TE Connectivity

Product Change Notification: P-19-017423

Mictor SB connector

comparison of before & after change

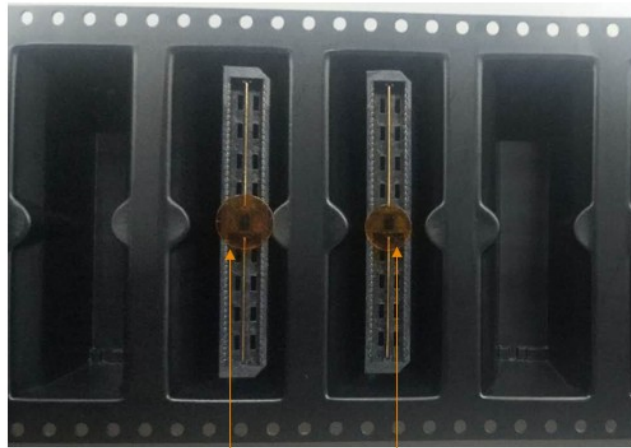
reduce the diameter of polyimide film pad(mylar for pick & place)

Product improvement.This change of polyimide film pad is just our design optimization and it is benefit for customer pick&place when soldering.
